10/555,156

Office Action Summary	Application No. 10/555,156	Applicant(s) FUJIWARA ET AL.	
	Examiner KINAM PARK	Art Unit 2828

DETAILED ACTION

Fig. 1. Schematic structure of the mode-hop-free DBR laser.

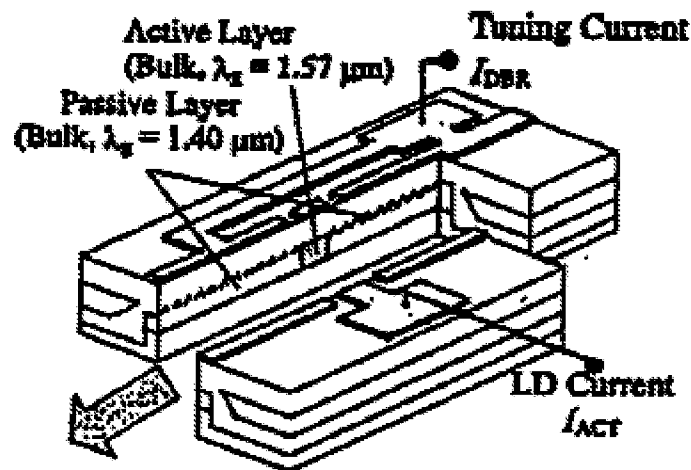
Fujiwara et al. discloses in figure 1 and specification:

a first passive region optical waveguide (see, Passive Layer) including a first DBR region having a diffraction grating in a section whose length corresponds to effective length of 95% or more of the saturated effective length value of the first DBR regions(see, figure 3 & 4), wherein the lasing wavelength is controlled by a DBR control current (see, I_{DBR}),

a second passive region optical waveguide (see, Passive Layer) including a second DBR region having a diffraction grating in a section whose length corresponds to an effective length of 75% or less of the saturated effective length value of the second DBR region (see, figure 3 & 4), wherein the lasing wavelength is controlled by the DBR control current (see, I_{DBR}), and said length of the second DBR region is within a range where the effective length of the second DBR region increases/decreases lineally in relation to the length of the second DBR region (see, in figure 3, the linearity in the range of an effective length of 75% or less of the saturated effective length value), and

an active region optical waveguide (see, Active Layer) in which the first passive region optical waveguide and the second passive region optical waveguide are optically connected at both ends, wherein emission state is controlled by the active region current (see, I_{ACT}), irrespective of the DBR control current.

wherein according to an increase or decrease in the DBR control current, a refractive index of said active region optical waveguide equally decreases or increases (see, left section, line 15, p. 1133), respectively, in accordance with a refractive index of the first DBR region and the second DBR region such that a ratio of the lasing

wavelength shift quantity to the Bragg wavelength shift quantity is maintained in a range from 0.9 to 1.1 (see, (1) and (2), right section, p. 1132, also, (5), left section, p.1133).

Note that Fujiwara et al. discloses in figure 1 and specification a first electrical isolating region and a second electrical isolating region (see, the separation of electrode) (claim 13, 30,36), the length of active region in a range from 30 μm to 100 μm (see, figure 5) (claim 15, 18, 21, 23, 31-32, 37-38).

Fig. 12. Structure of the 4-ch mode-hop-free DBR laser array.

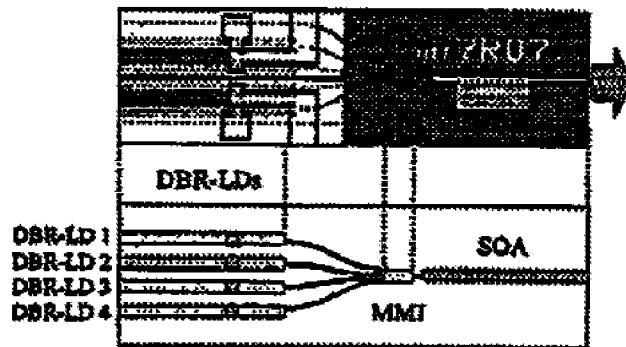
Fujiwara et al. also discloses in figure 12, an optical coupler (see, MMI) and an optical semiconductor amplifier (see, SOA).

However, Fujiwara et al. is silent as to the plurality of wavelength tunable DBR laser having different pitches of the diffraction grating.

Ikeda et al. discloses the diffraction grating with different grating (see, col.1, lines 15-22).

Therefore, it would have been obvious to a person of ordinary skill in the art at the time of invention to combine the diffraction grating with different grating of Ikeda et al. with a wavelength tunable DBR laser of Fujiwara et al because this provides a plurality of laser light beams having different wavelengths (see, col.1, lines 15-22 of Ikeda et al.).
